MD355 Crossing (BRAC) Project, CIP Project 501209, Mandatory Referral No. MR2014024

Completed: 12/19/13

We recommend that the Board **approve** this project with the following comments to MCDOT.

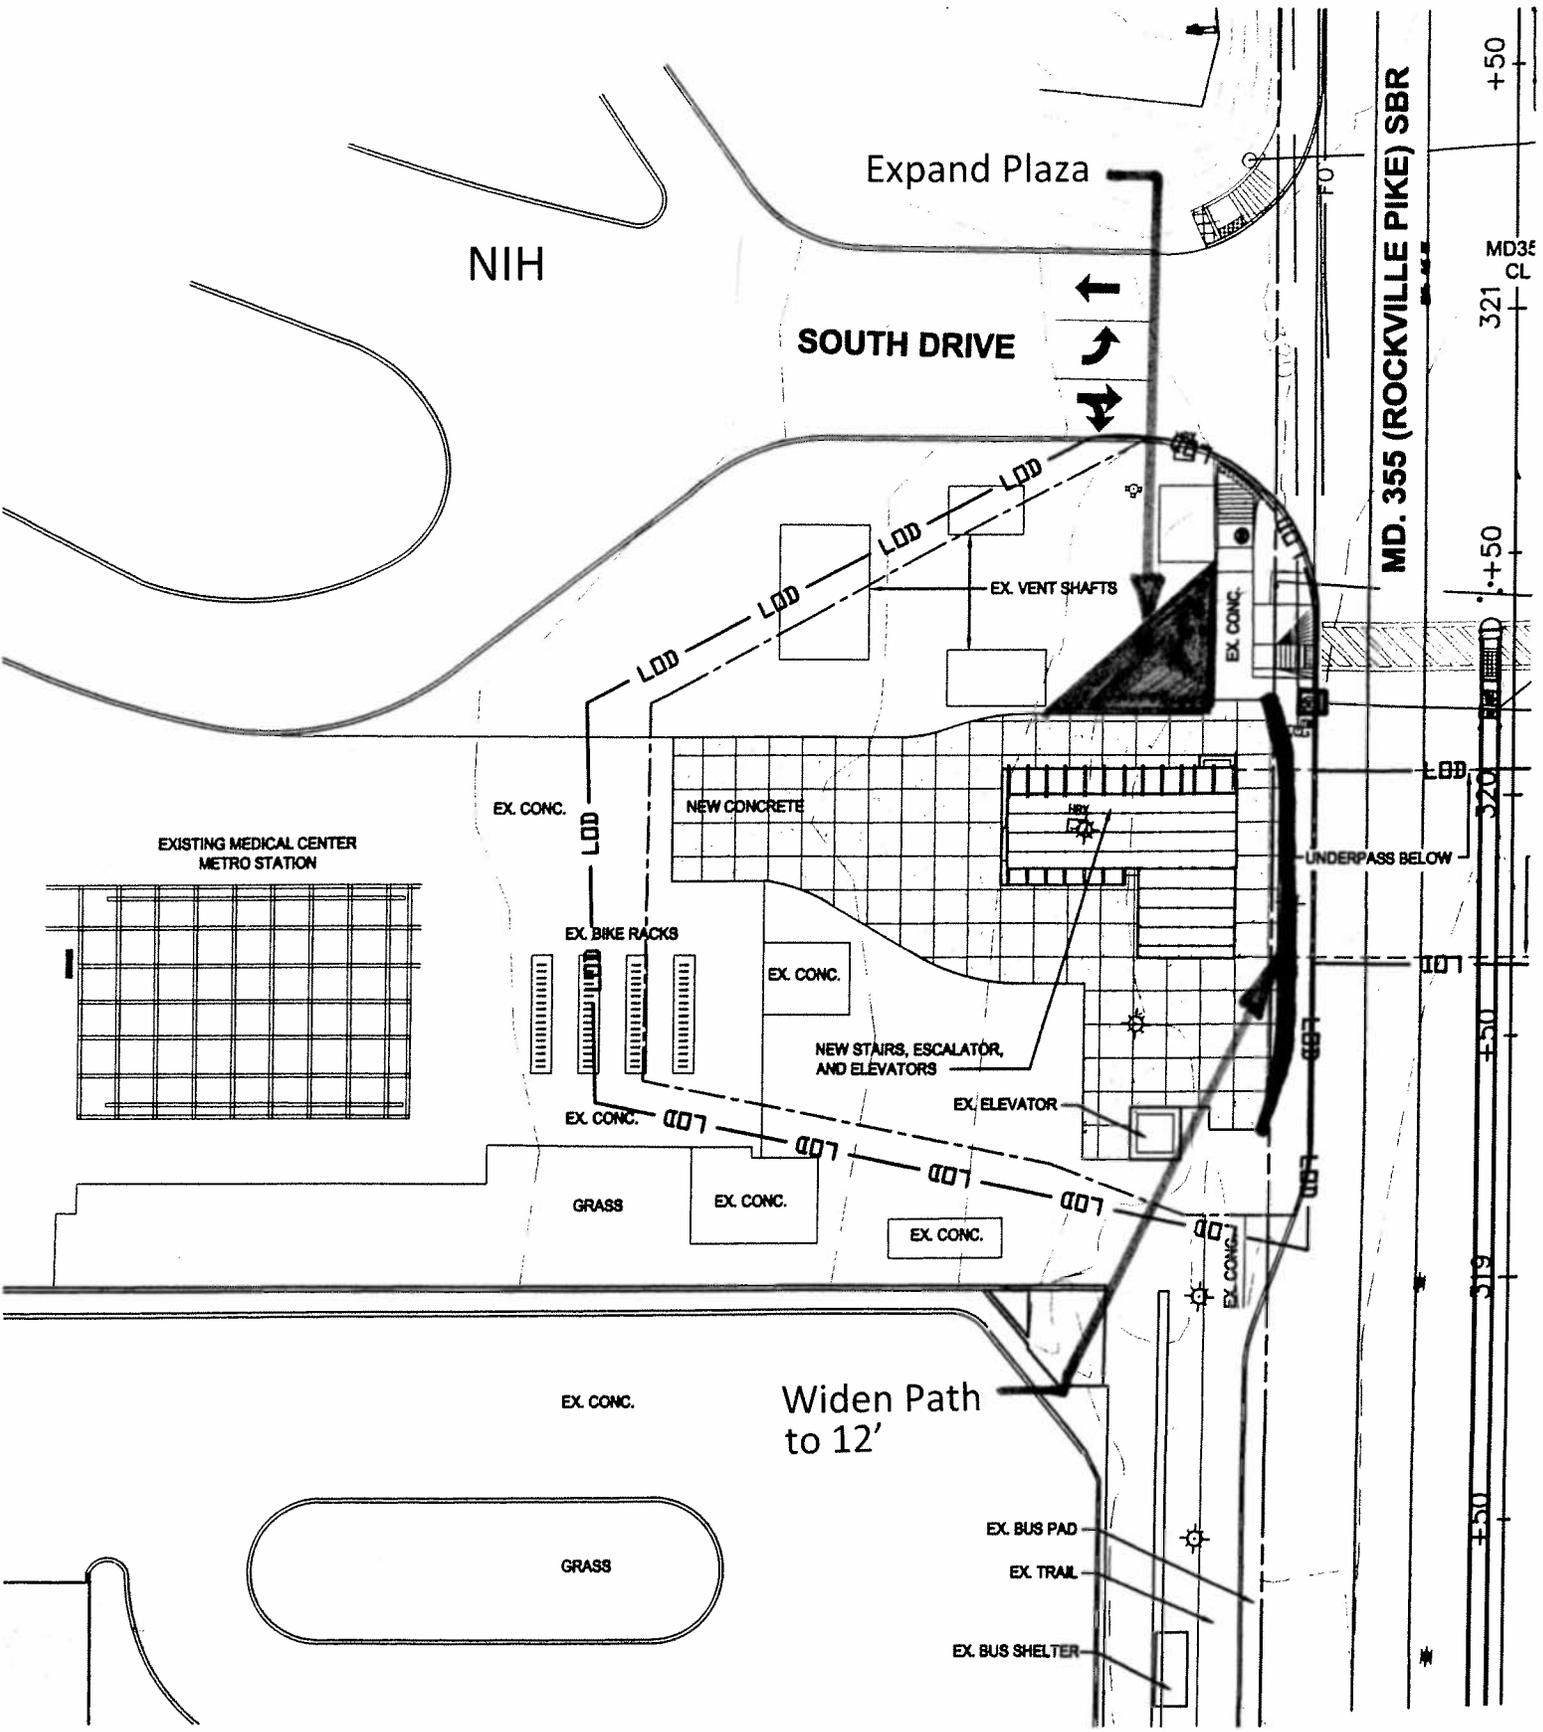
1. Expand the plaza area on the west side of MD355 to the north to eliminate the need for users of the crosswalk on the south leg of the intersection to make two right turns to access the Metro station or enter the National Institutes of Health (NIH).

2. Increase the width of the bike path adjacent to the tunnel portal on the west side of MD355 to twelve feet if possible to provide a “shy distance” from the portal wall.

On the west side of MD355, improvements should be made to facilitate pedestrian and bicyclist movement (see Attachment 4):

- The plaza area should be expanded in the area of the handicap ramp to eliminate the need for users of the crosswalk on the south leg of the intersection to make two right turns to access the Metro station or enter NIH.
- The bike path width on the east side of the tunnel portal should be increased to ten feet.

Attachment 5

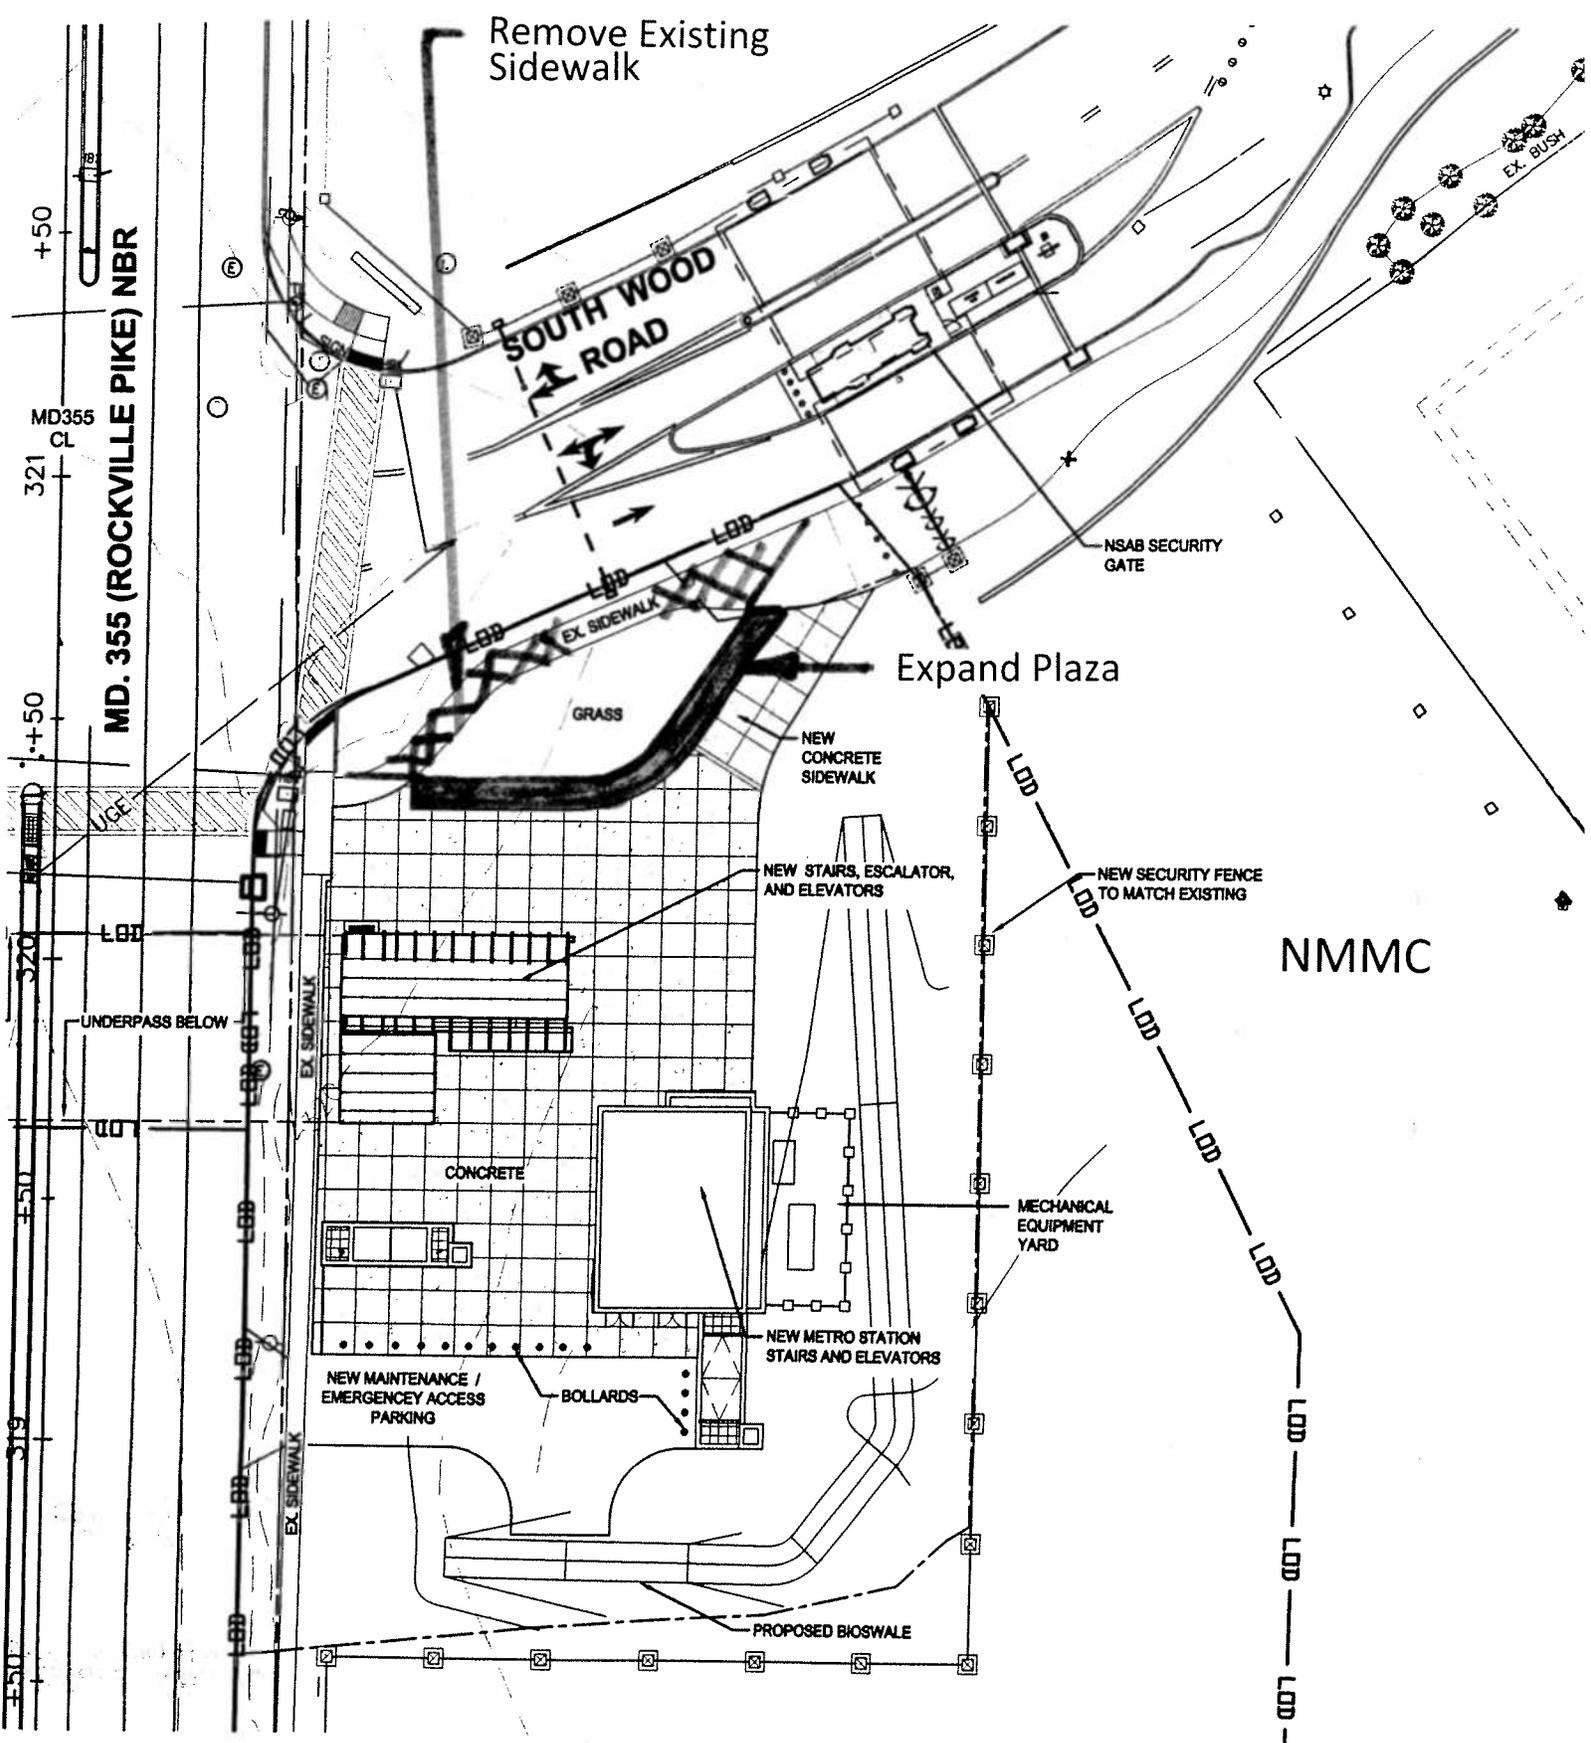
3. Expand the plaza area on the east side to the north to facilitate a smooth movement for users of the crosswalk on the south leg of the intersection headed toward NMMC.

4. Remove the existing short and narrow sidewalk segment that runs along South Wood Road to improve pedestrian movement in this area and to allow a better landscaped buffer between the plaza and the road.

On the east side of MD355, the following improvements should be made (see Attachment 5):

- The plaza area should be expanded on the north side to facilitate a smooth movement for users of the crosswalk on the south leg of the intersection headed toward NMMC. The existing short and narrow sidewalk segment that runs along South Wood Road should be deleted for clarity of movement in this area and to allow a better landscaped buffer between the plaza and the road
